ChiCycle Concerns over West of Chichester Southern Access Road Proposals

ChiCycle Concerns over Westgate Shared Pavement Proposals

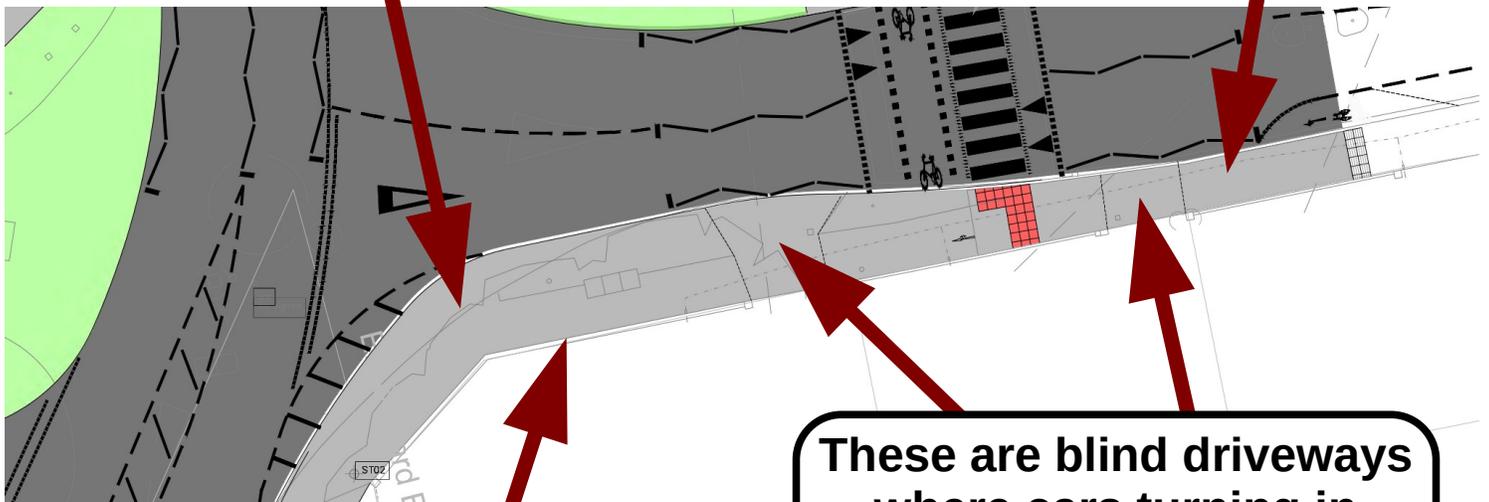
This is a blind corner that does not meet DfT guidelines on forward SSD visibility for cycle tracks

Here pavement is only 62% of the minimum DfT prescribed width for shared use

An osteopathy clinic is located here with patients accessing the pavement at a blind exits. Two way cycle traffic on this pavement is particularly inappropriate

These are blind driveways where cars turning in will have right of way over cyclists

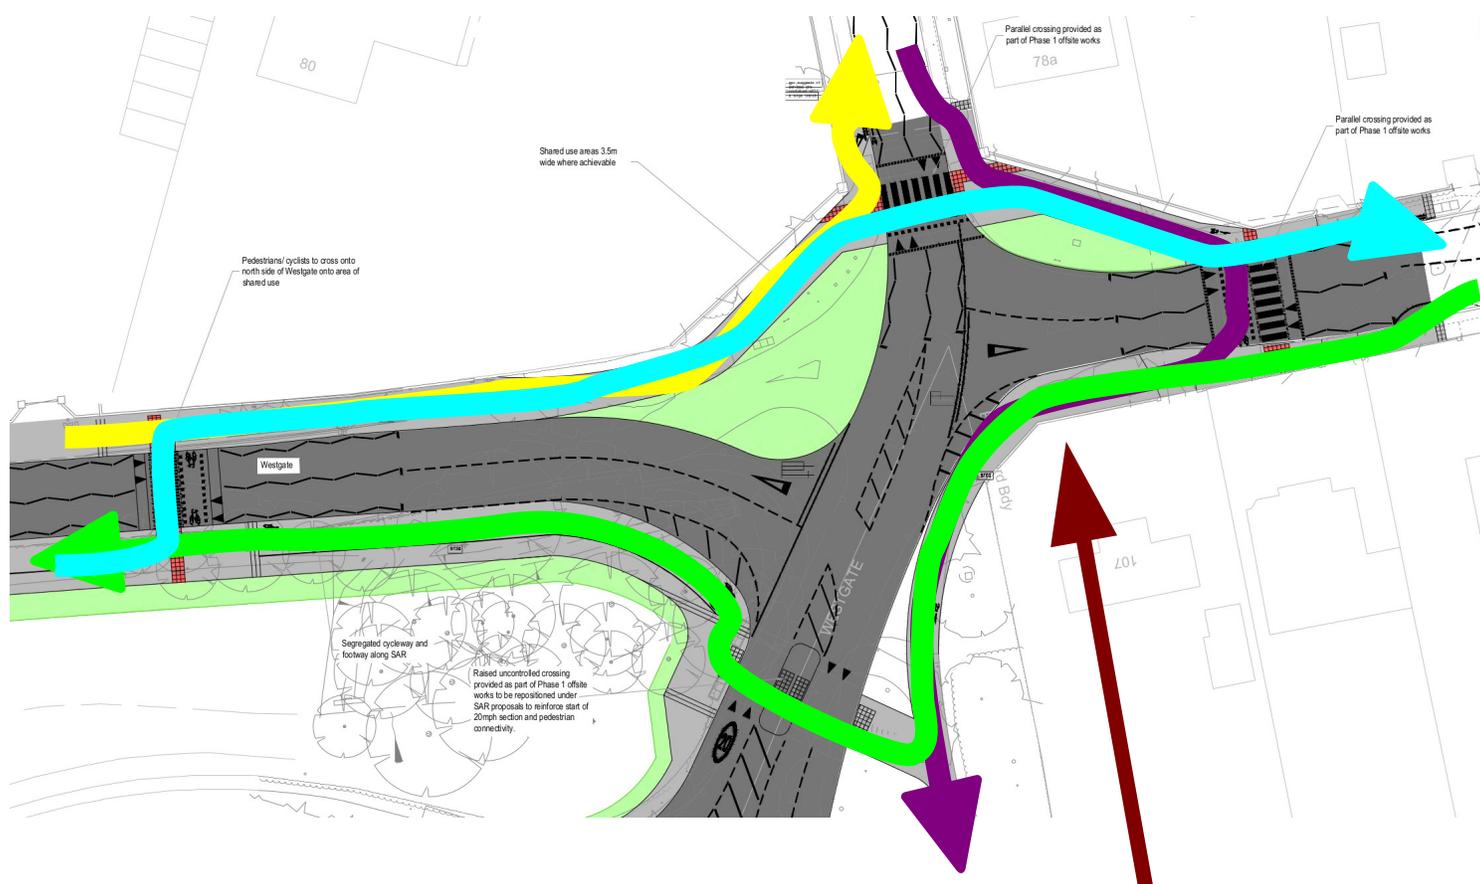
Staggering the junction between West and East sections of Westgate creates a convoluted poorly connected route for cyclists using this route.

The diagram below illustrates some of the issues created for cyclists created by staggering the junction.

This is a blind corner that does not meet DfT guidelines on forward SSD visibility for cycle tracks

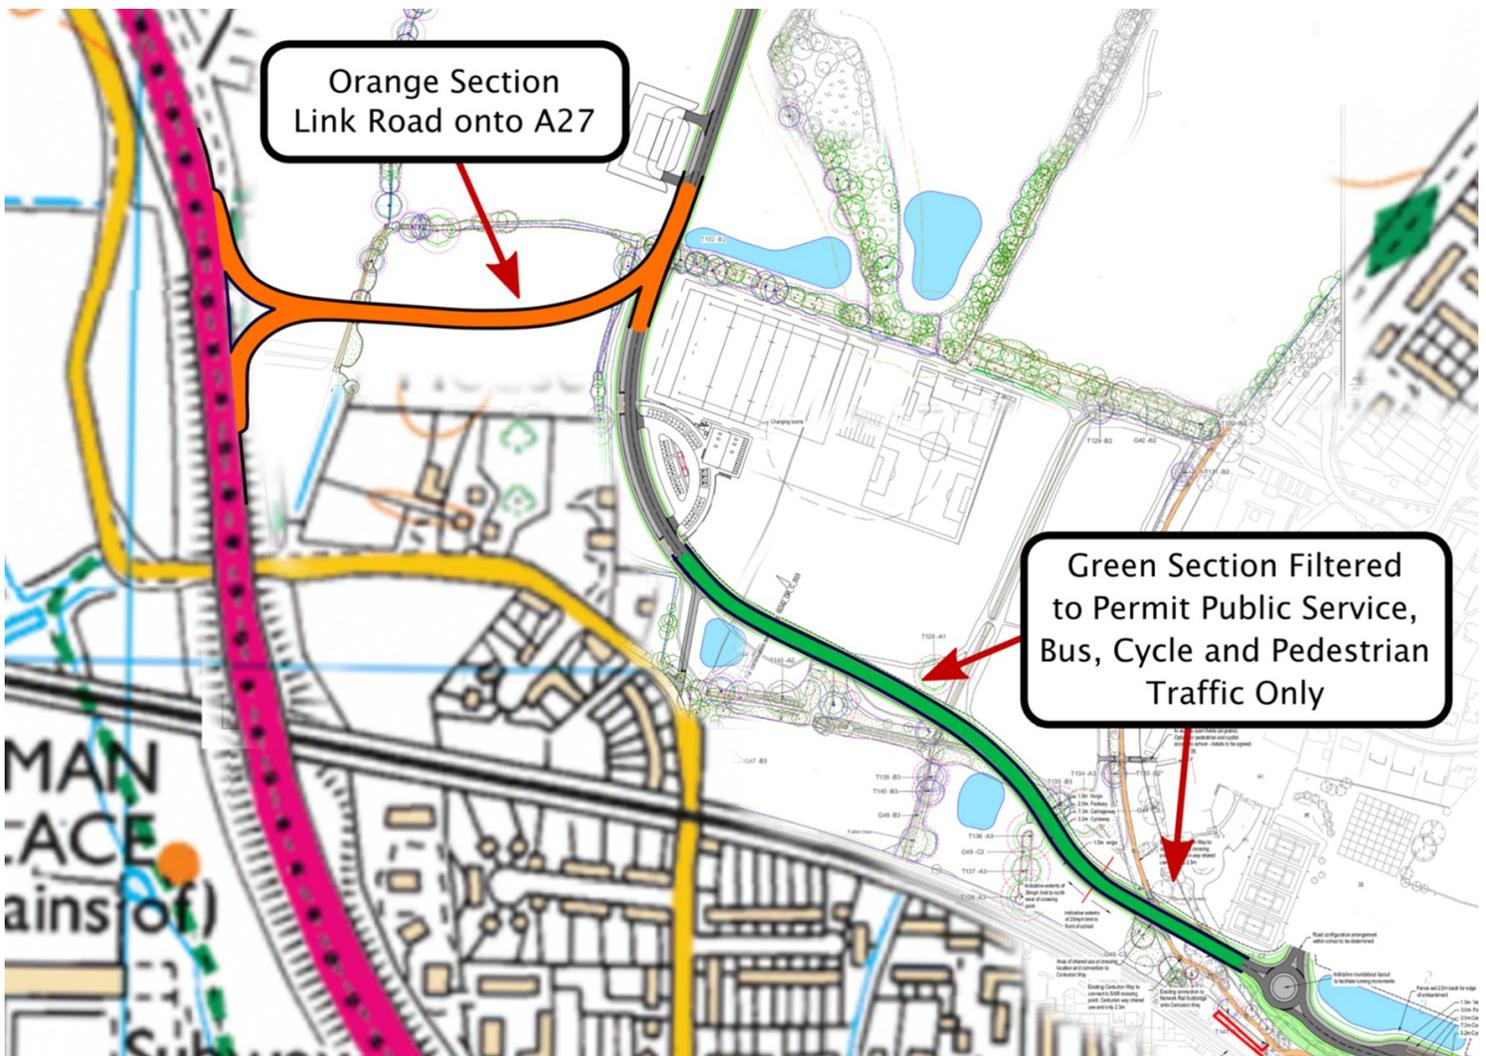
Is it desirable or necessary to lead this busy road into and through a residential area used as the city's main East West walking and cycling route?

The Southern Access Road runs relatively close to the A27 before making a lengthy passage away from a main road, across national cycle ways, through Bishop Luffa school, to then join onto an existing quiet cycle street before causing conflict with pedestrians and cyclists at Sherbourne Rd. Might a better option be to join the spine road directly to the A27 as has been done using two junctions at the Shopwyke estate?

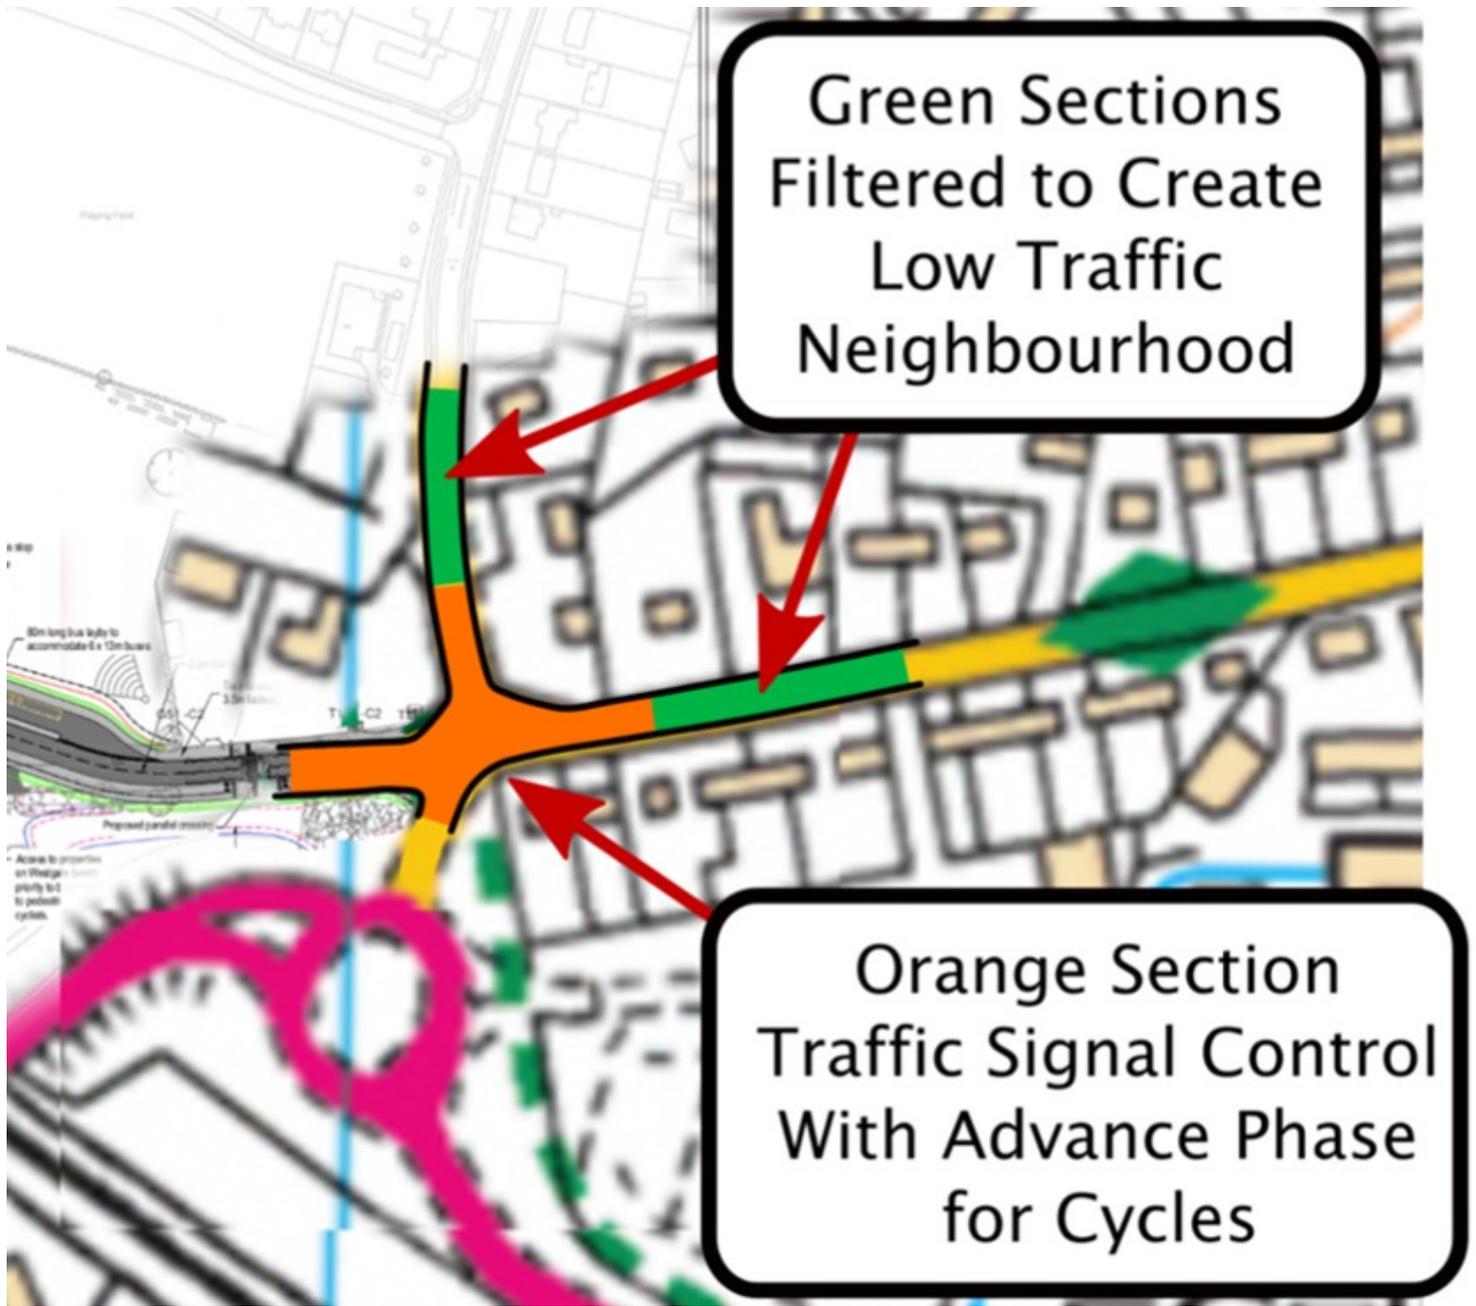
Slip roads leading from an existing highway bridge onto the A27 could bypass existing A259 traffic currently routed through Fishbourne. This will also allow new residents of the West of Chichester Development an easy access onto the strategic road network

Maintaining the alignment of East and West sections of Westgate can provide an acceptable through route for cyclists. Filtering traffic to create a Low Traffic Neighbourhood will allow this route to become a viable cycle way

Stepped cycle ways on either side of the road would link acceptably to allow a continuous route

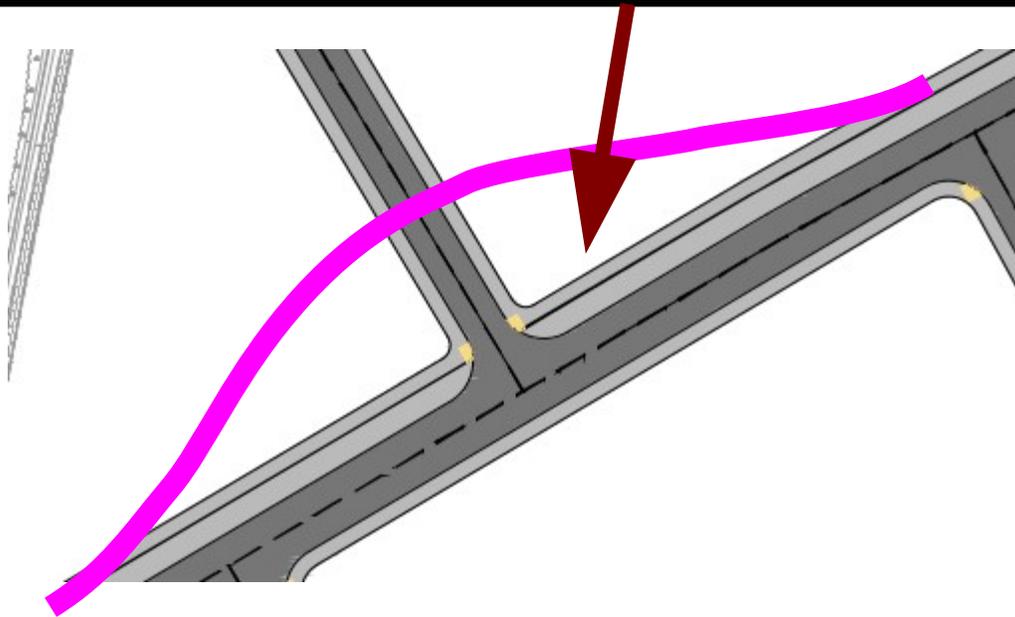
This replicates similar failures of the Northern Access Road where priority was promised for cyclists but is not provided! According to the DfT cyclists can not have priority over cars turning in at this type of cycle crossing.

This approach is suitable for one way tracks traveling in the same direction as the adjacent traffic lane, as shown in figure 10.17. Drivers must give way to cyclists when leaving the side road, but there is no priority for cyclists over traffic turning in.

Joining the cycle way to the end of the vestigial remnant of the original road may be a better option than running a track flush over this side road access

This replicates similar failures of the Northern Access Road where priority was promised for cyclists but is not provided! According to the DfT cyclists can not have priority over cars turning in at this type of cycle crossing.

Consider “bending out” the footway and cycle track as recommended by DfT LTN1/20 in Figure 10.15: Full set back, marked priority (bent-out) crossing. Purple line indicates ChiCycles recommended route for pedestrians and cycles.

How will the cycle track and footway be segregated?
